SERVICE BULLETIN

MITSUBISHI MOTORS

PURPOSE : INFORMATION	ISSUE NO. : MSB-12EXML42-002	DATE : 2012-9-20
SUBJECT : ADJUSTMENT OF DOOR STRIKER FOR THE VEHICLES WITH SIDE-CURTAIN AIRBAGS		<Destination/Model> (ALL DESTINATIONS) <M/Y> ALL
GROUP : BODY		THE VEHICLES WITH THE SIDE-CURTAIN AIRBAGS

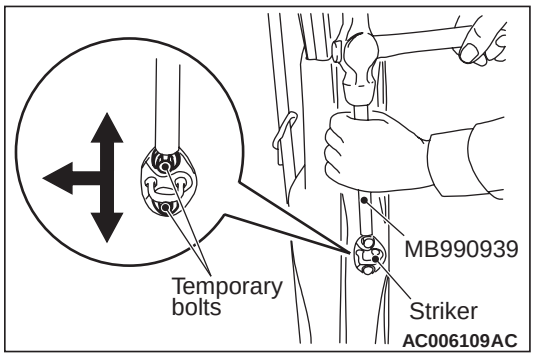
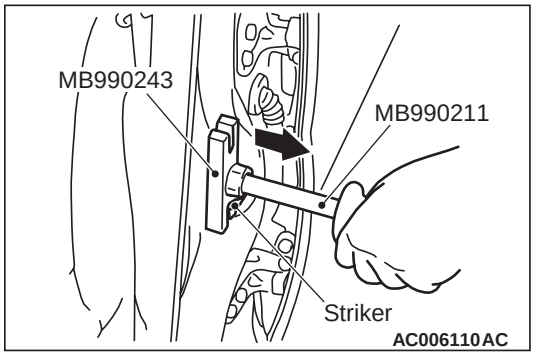
⚠ CAUTION
To adjust the striker, always turn the ignition switch to "LOCK" (OFF).

(1) Adjustment using the striker (toward the inside of the vehicle and vertical direction):

Install a temporary bolt instead of the striker mounting bolt, and use the remover bar (Special tool: MB990939) and a hammer to tap the temporary bolt to the desired direction.

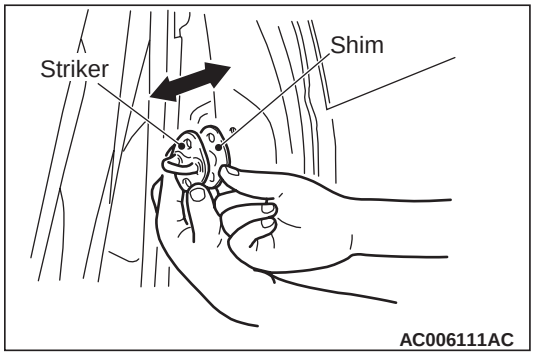
(2) Adjustment by using the striker (toward the outside of the vehicle):

Using the following tools, pull the striker toward the outside of the vehicle to adjust.

- Slide hammer (MB990211)
- Body puller (MB990243)
